No. 2053  
ATA Code 28-20

**SUBJECT:** FUEL SYSTEM - ADDITION OF A DECAL AND A FUEL SELECTOR STOP TO THE FUEL SELECTOR VALVE GUARD

**REASON:** To minimize the possibility of inadvertently turning the fuel selector valve to the OFF detent position.

Figure 1

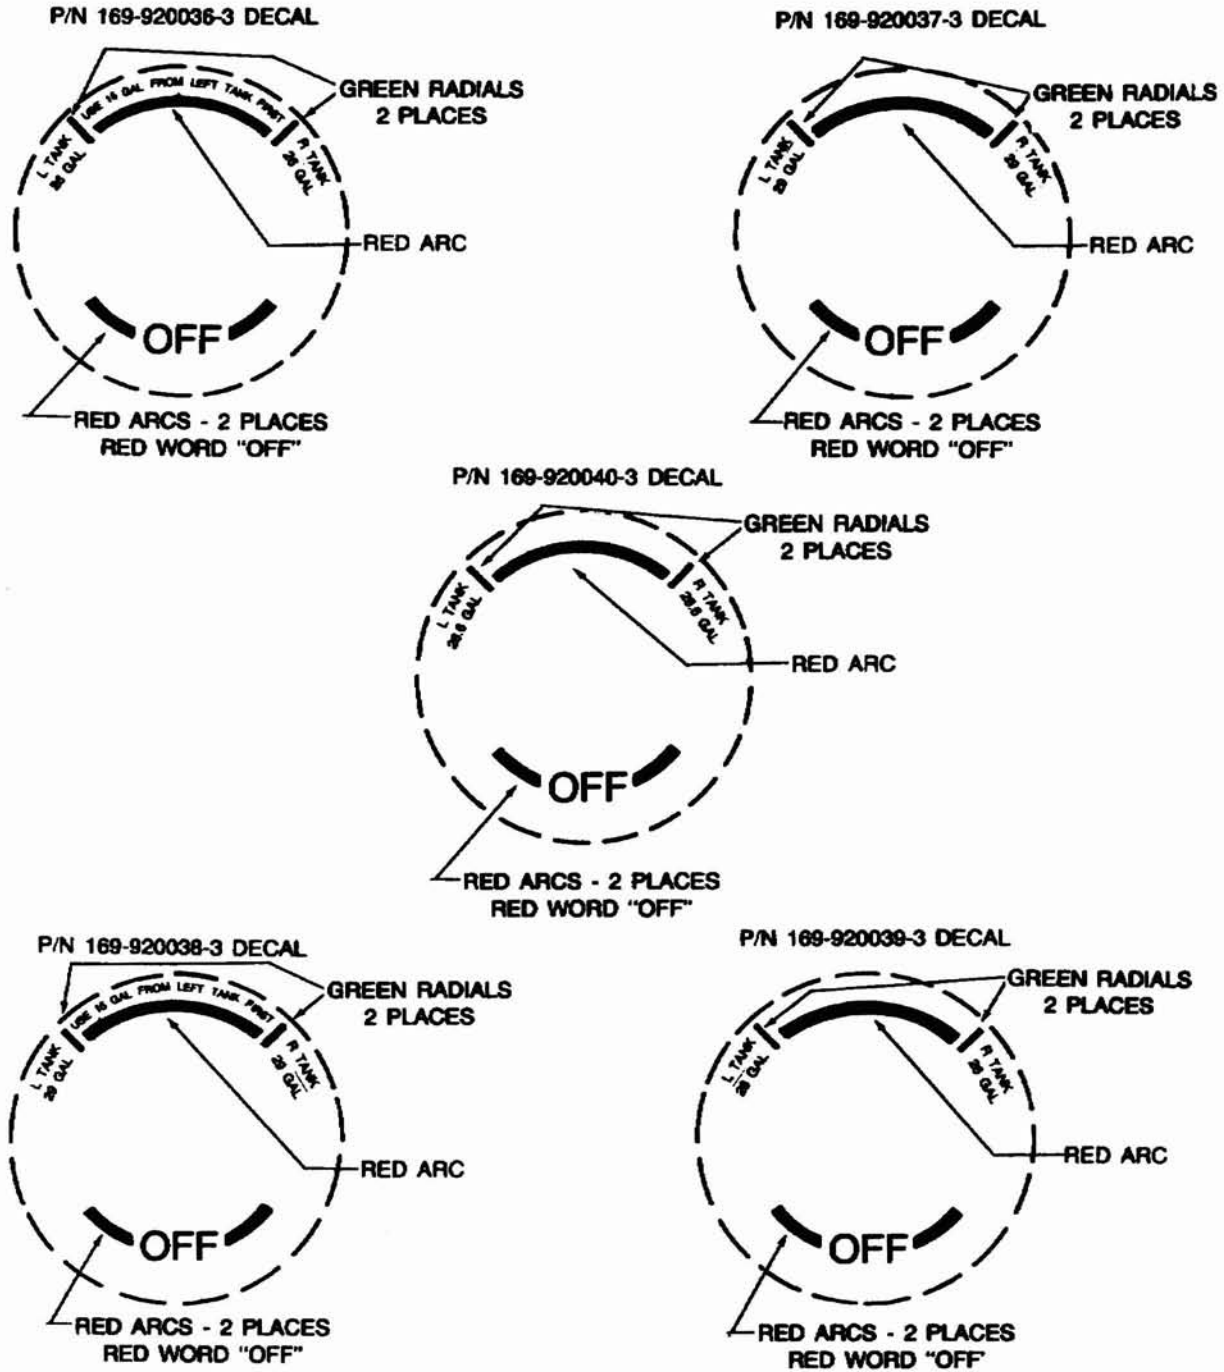
3. Install the appropriate pressure sensitive decal, as determined from Figure 1 and from the MATERIAL section, to the fuel selector valve guard.

2. Inspect the fuel selector valve guard for the correct placard. Placard instructions, if any, and usable fuel amounts should match one of the decals shown in Figure 1. Refer to MATERIAL section.

Figure 2

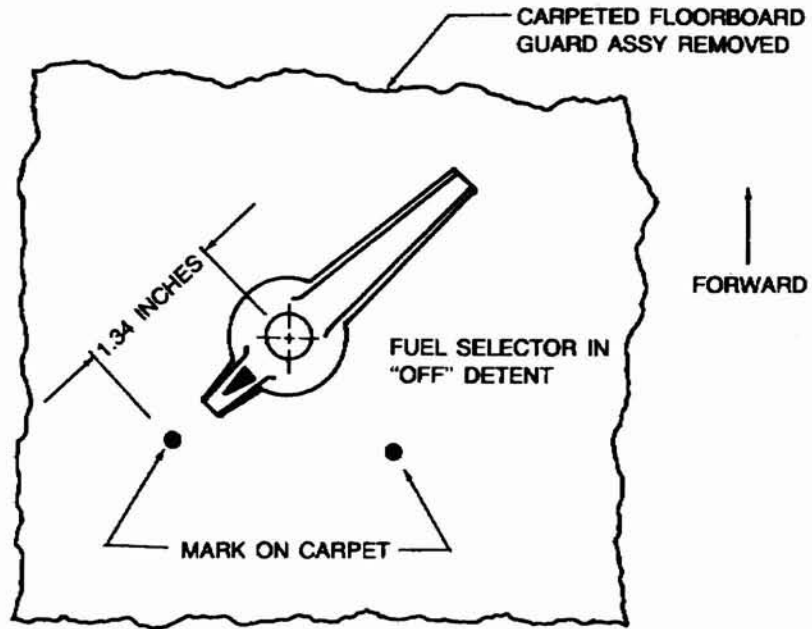
4. Replace the fuel selector valve handle and turn the handle to one of the "OFF" detents. Refer to Figure 2.

Figure 3

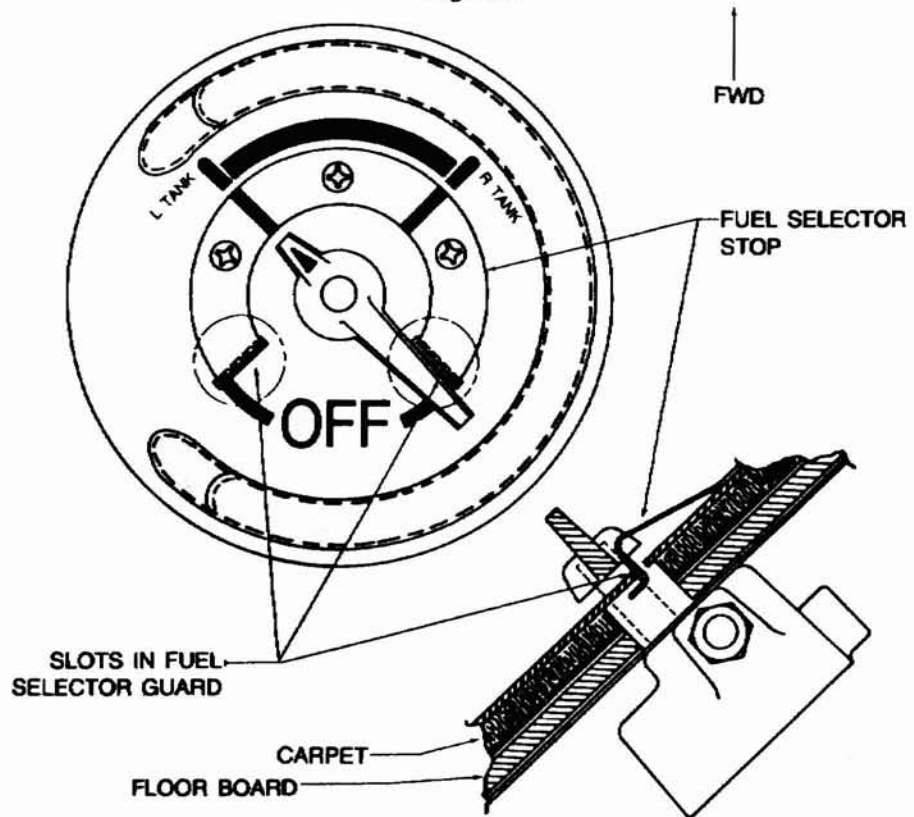
13. Mark and cut two slots .20 inch by .90 inch to clear the vertical legs of the selector stop, as shown in Figure 3.

15. Attach the fuel selector handle, and position the guard and the fuel selector stop so that the green radials on the guard and the fuel selector stop line up with each other and with the index on the fuel selector handle as shown in Figure 3. It may be necessary to trim the nap of the carpet under the flat surface of the guard in order to provide sufficient clearance between the guard and the fuel selector handle.
